# **Australian Institute of Landscape Architects Position statement on East West Link – Stage One**

Draft - 31st July 2013

**Analysis of Proposed East West Link Landscape Impacts  
ROYAL PARK AND MOONEE PONDS CREEK**

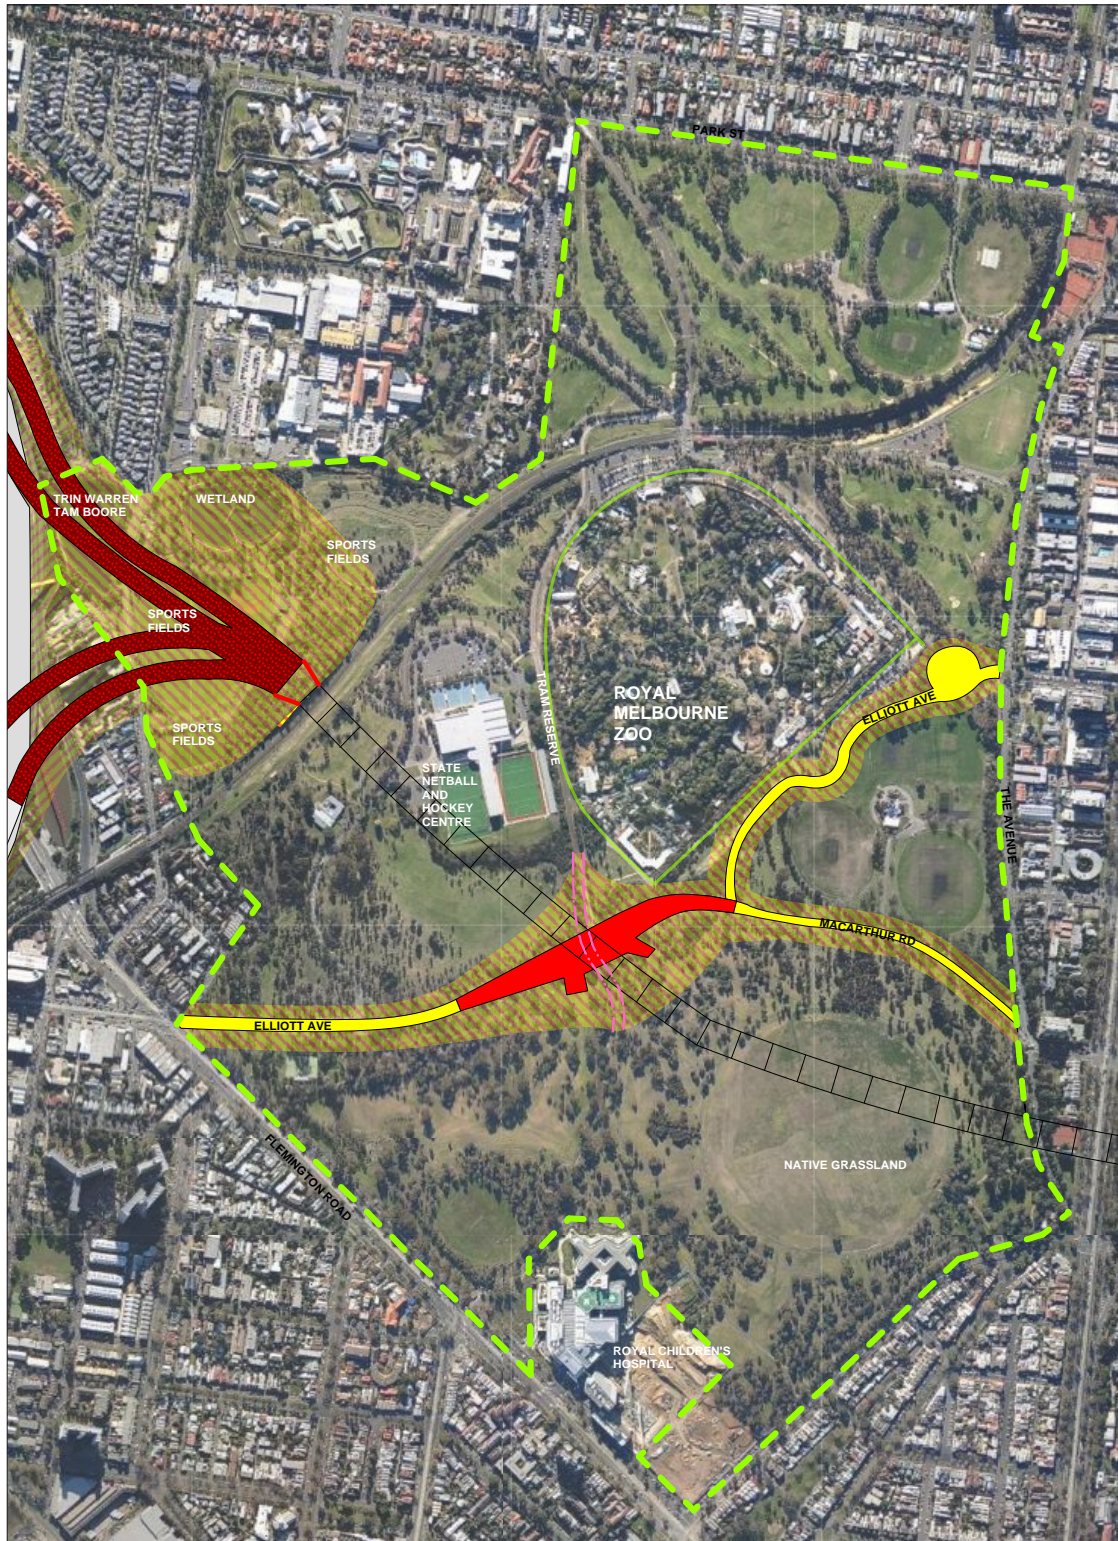
The current design for East West Link Stage 1 has substantial and unjustified impact on Royal Park and will also severely compromise the future development and enhancement of Moonee Ponds Creek.

We believe the inappropriate route and intersection designs of East West Link Stage 1 make the project as it is currently presented irreparably flawed. No amount of landscape architectural work would be able to adequately offset or rectify the project's impacts.

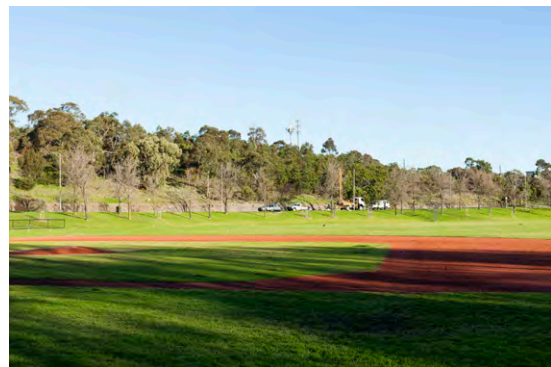
The East West Link Stage 1 proposal for this section of the park is also immensely damaging. The design proposes a tunnel exit to the west of the rail line and elevated road flyovers which will occupy the entire western section of the park.

This Manningham Reserve section of the park is home to well-used sports fields and the new and stunning Trin Warren Tamboore, a secluded bird habitat and state of the art system of stormwater treatment ponds and wetlands. The notes on the drawings state that Ross Straw Field will be 'occupied for construction' but the plan indicates that most of this area will be permanently lost, with no usable area for sports remaining in this part of the park. Much of the wetlands west of Manningham Street will be lost or overshadowed (and hence permanently compromised) by elevated freeway structures.

Needless to say the tranquillity, natural qualities and amenity of this large western segment of Royal Park will be diminished beyond recognition forever by the proposed road design even if some of its existing features are retained or rebuilt.
